FROM: AMHI Center Building Storage Addendum 2
TO: Prospective Bidders, Suppliers, and Other Parties
RE: Addendum No. **2 (Two)** to the Bidding Documents

AMHI Center Building Storage, Augusta ME

ADDENDUM 02 - 10.27.2021

AD1.13

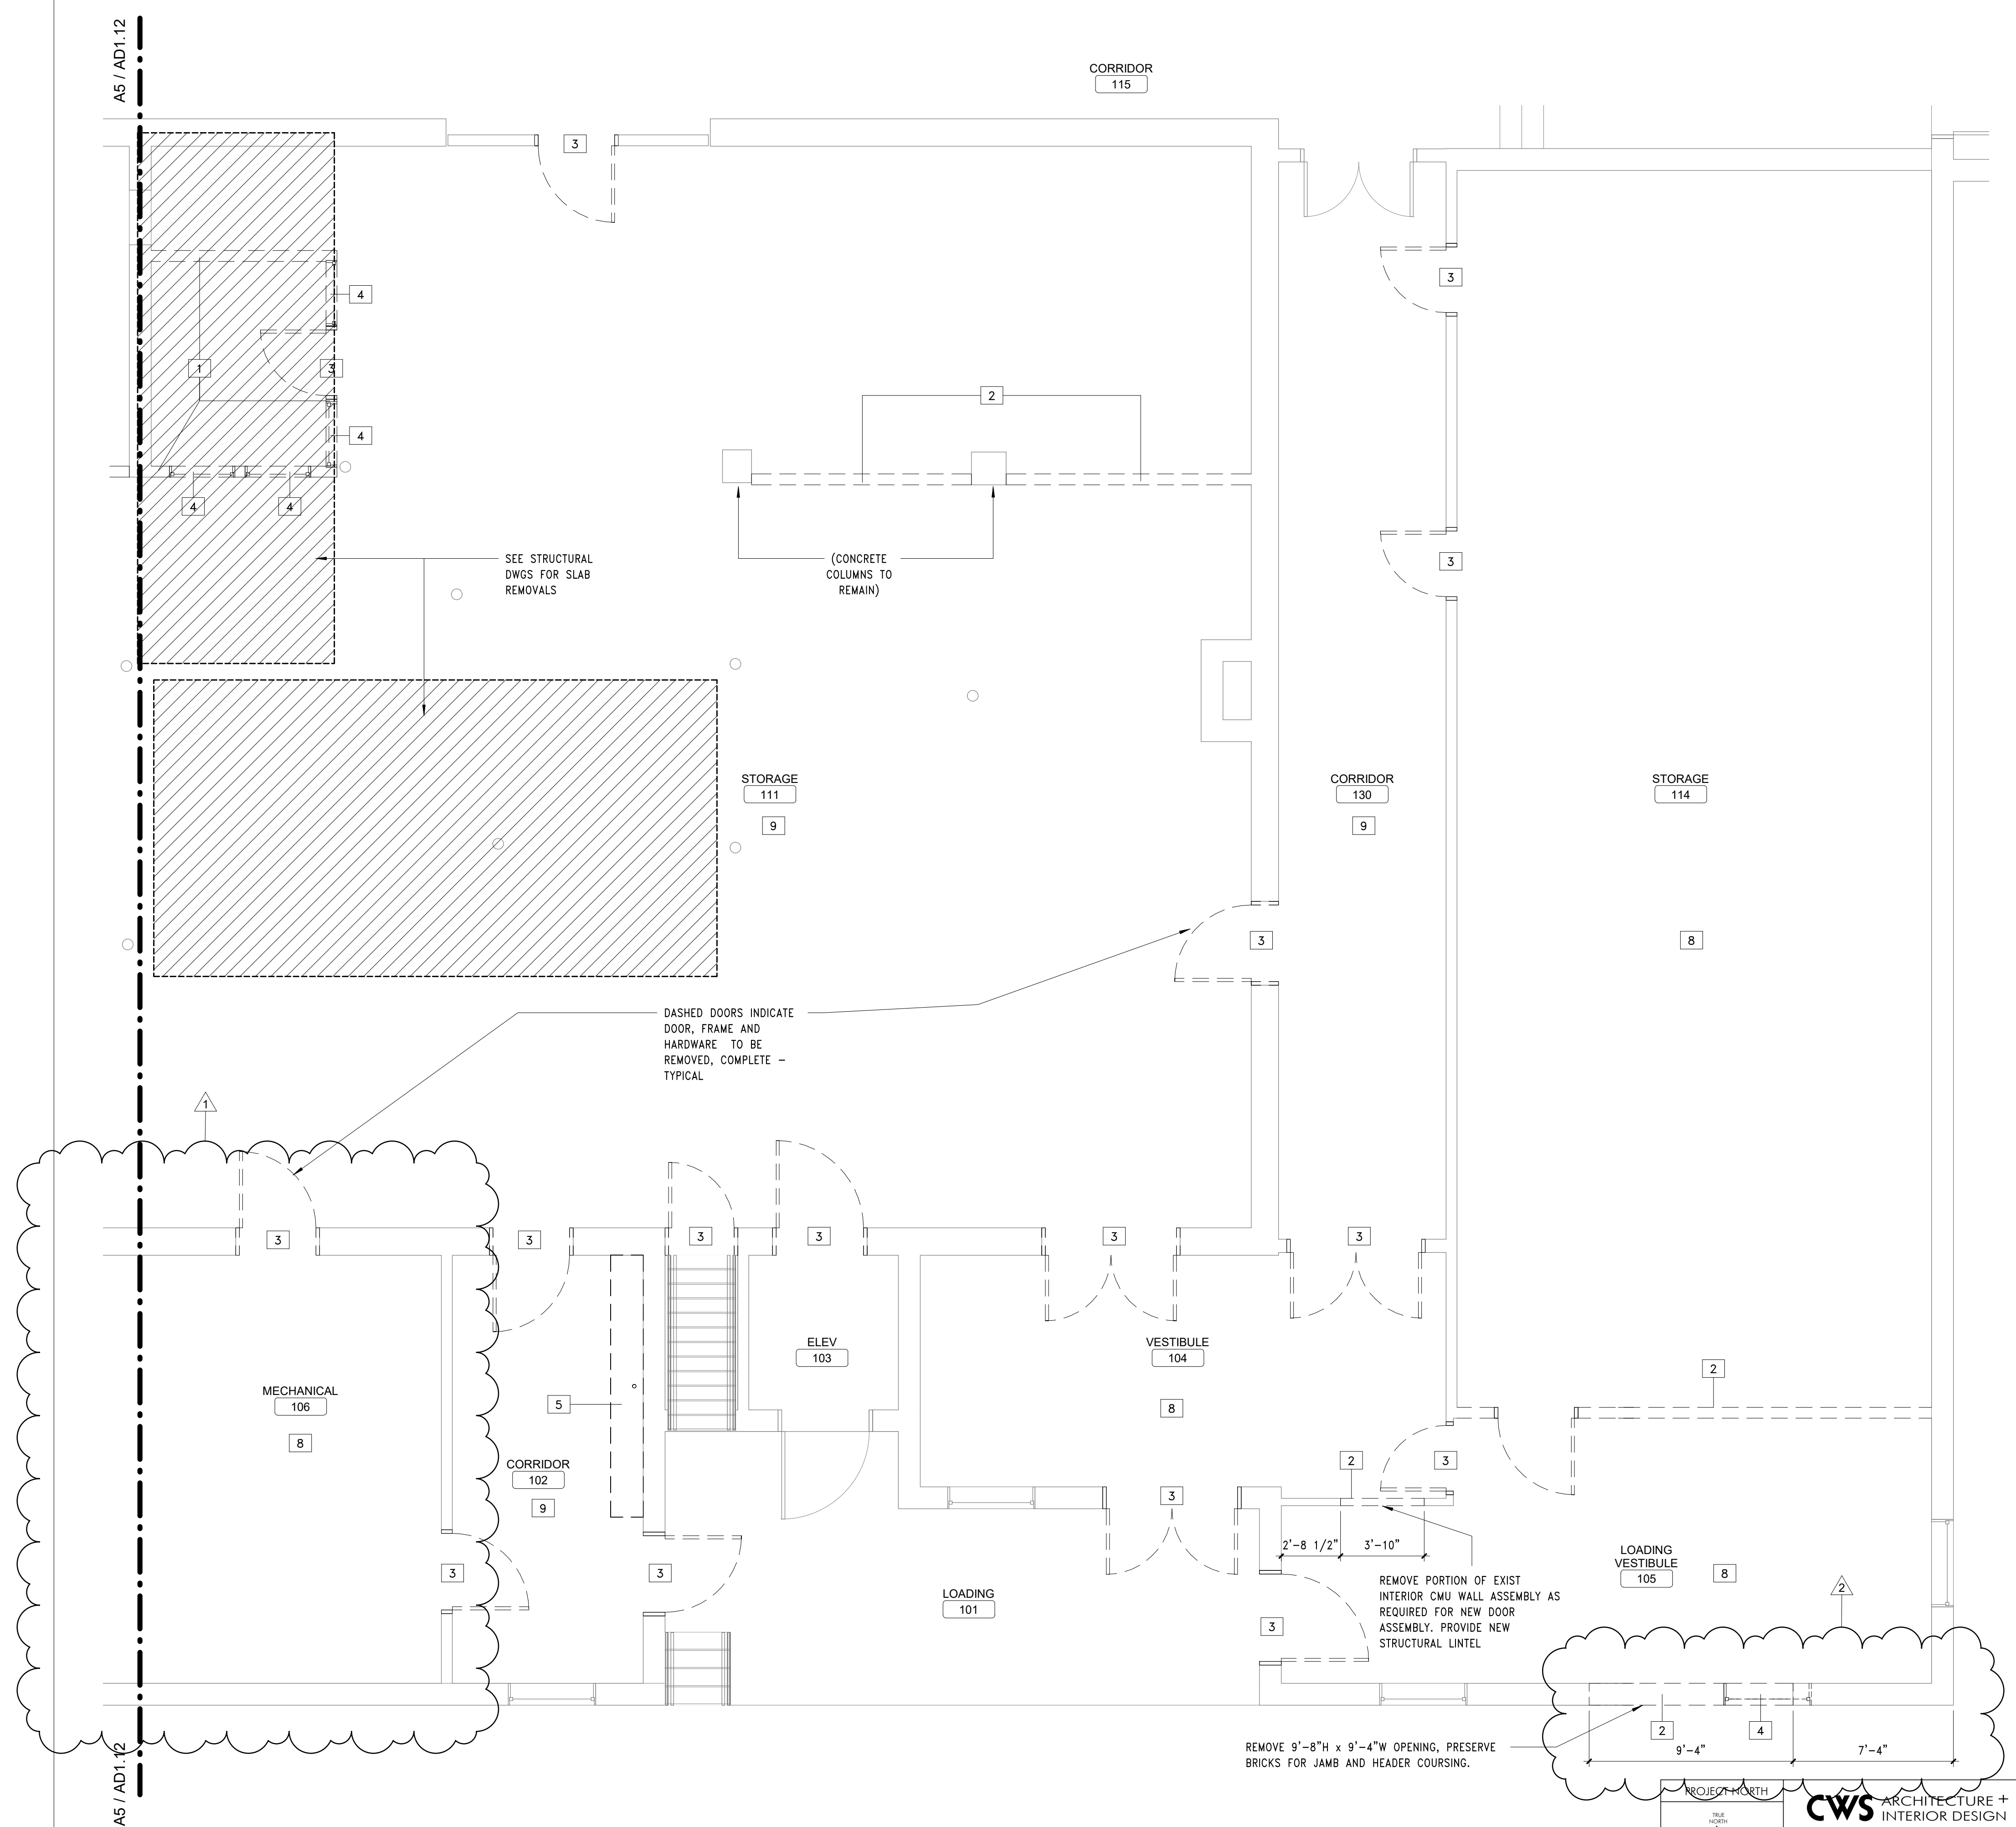
1. **SHEET G-000**– **ADDED** sheet SF-400 – STRUCTURAL-ENLARGED FRAMING PLAN AND DETAILS
2. **SHEET AD1.13**– **MOVED** Overhead door moved 16” west
3. **SHEET A1.13** – **MOVED** Overhead door moved 16” west
4. **SHEET A2.13**– **MOVED** Overhead door moved 16” west
5. **SHEET S-000** – **ADJUSTED** limit of AREA-B loading
6. **SHEET SF-100** – **ADJUSTED** Limit of tractor travel, **ADDED** enlarged plan D6/SF-400
7. **SHEET SF-110** – **REPLACED** Note 1 of the ROOF AND EXTERIOR FAÇADE CONDITIONS
8. **SHEET SF-200** – **REPLACED** Note 1 of the ROOF AND EXTERIOR FAÇADE CONDITIONS
9. **SHEET SF-201** – **REPLACED** Note 1 of the ROOF AND EXTERIOR FAÇADE CONDITIONS
10. **SHEET SF-400** – **ADDED** Sheet in its entirety
